PRIVATE WATER DISTRIBUTION SYSTEM IMPROVEMENTS

CHICKEN N PICKLE AT PLAZZIO

PROJECT NO.
2124PPW (183021)

AS BUILTS

WATER LINE 1

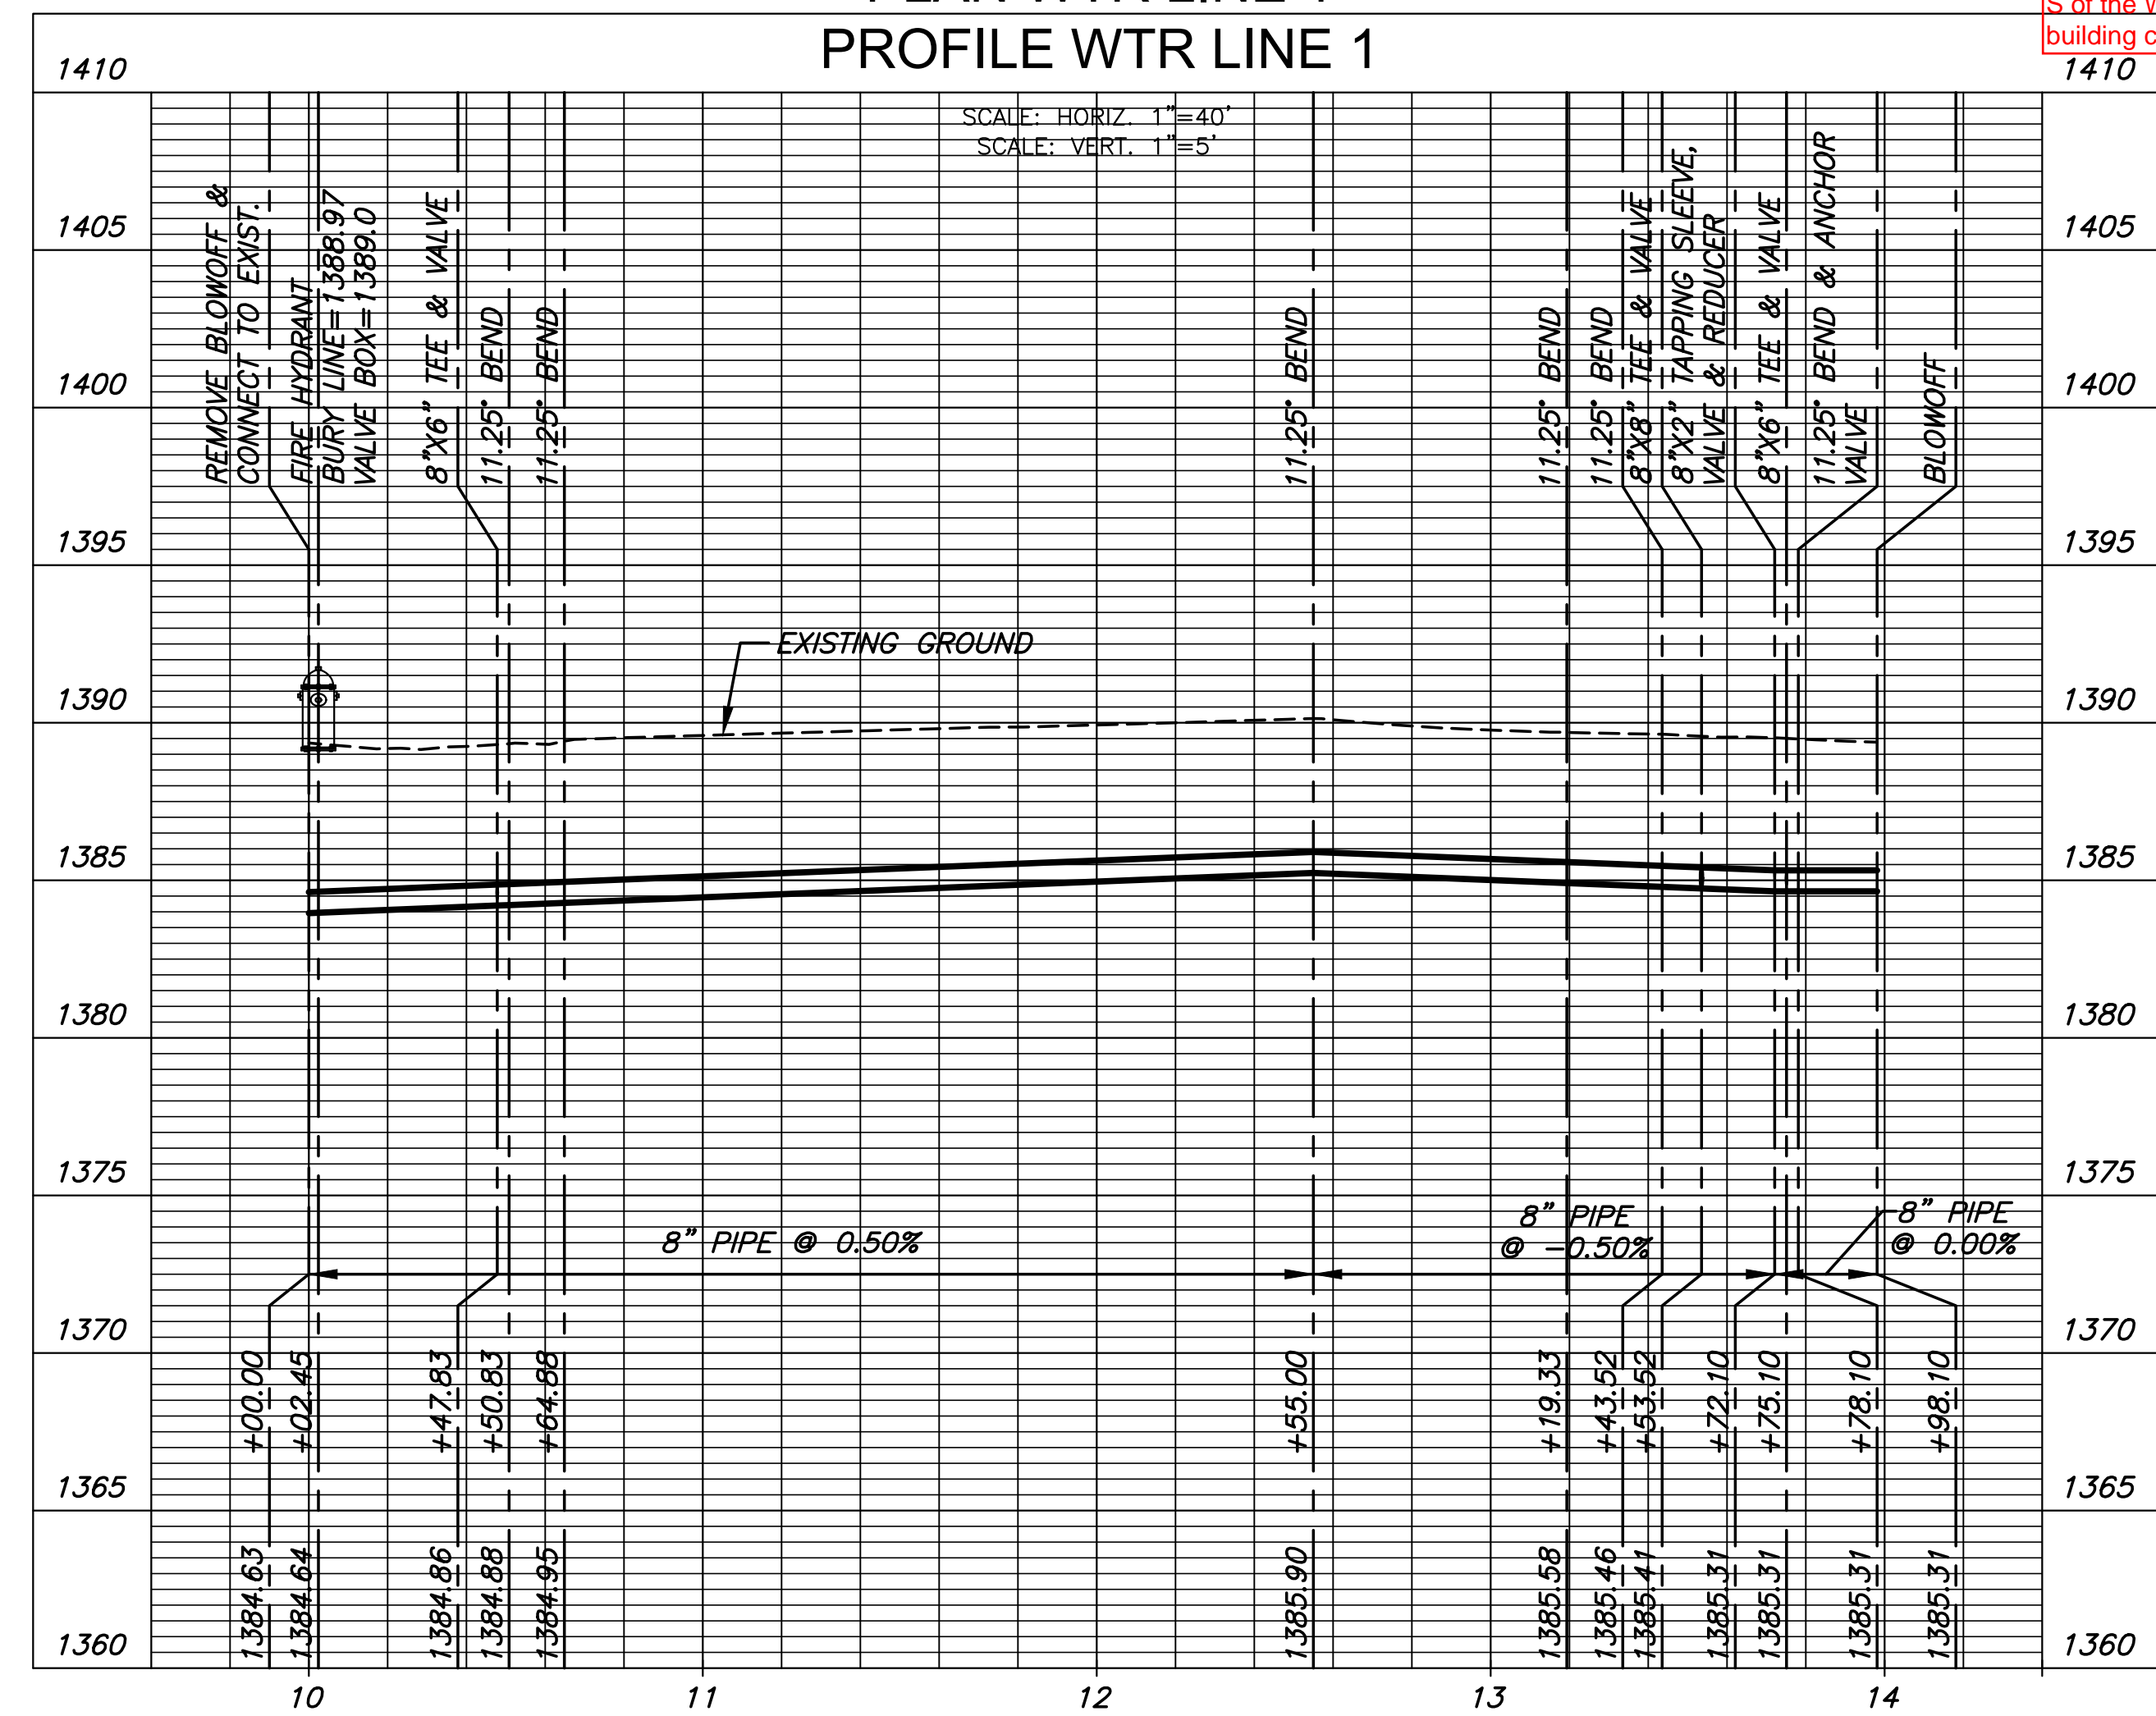
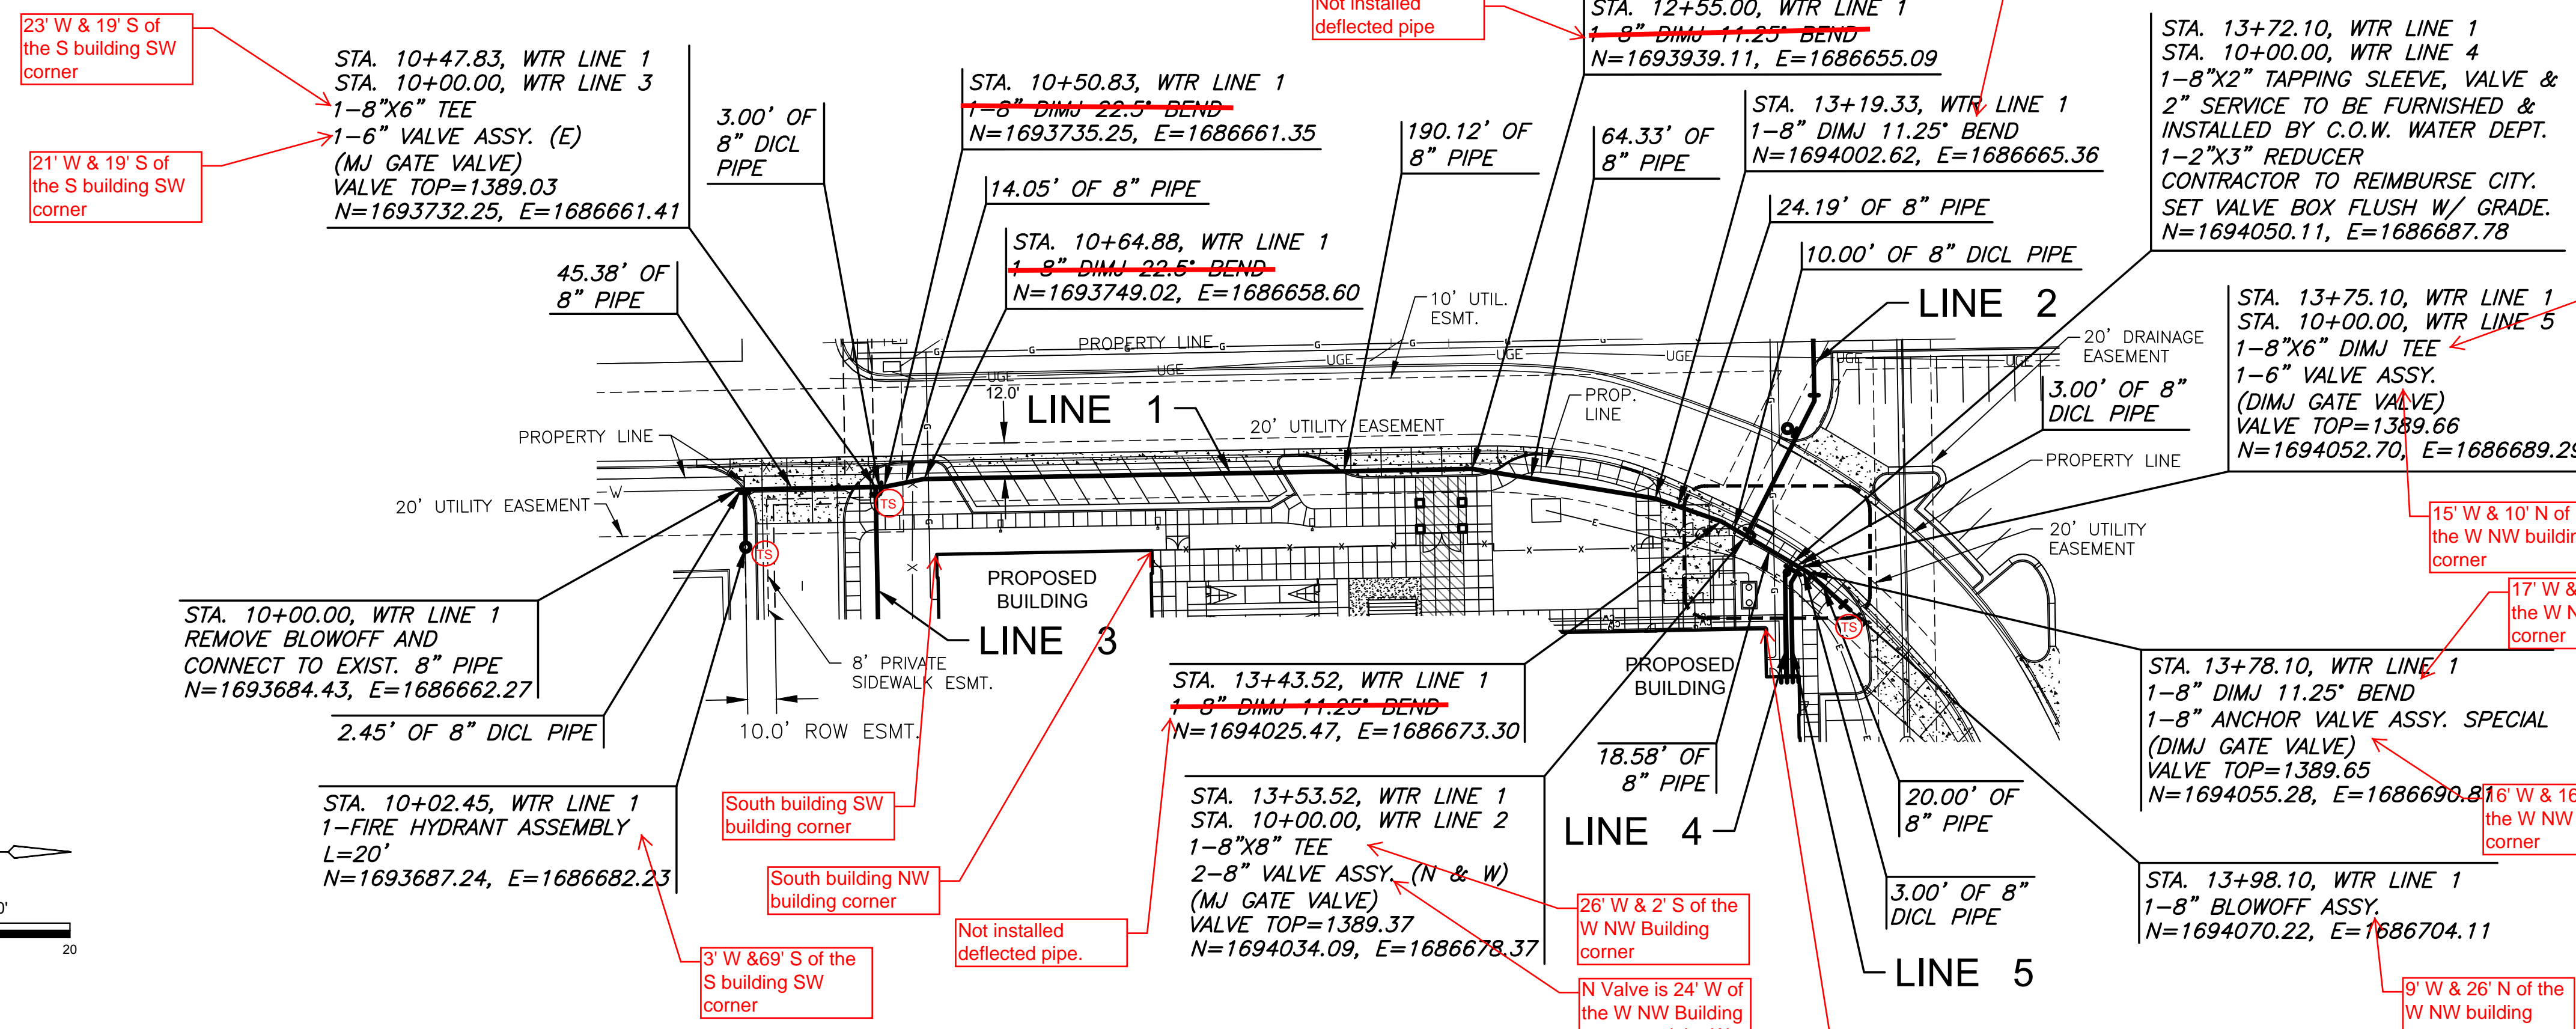
Waterline was moved 1.5' west due to gas line located where the waterline was to go.
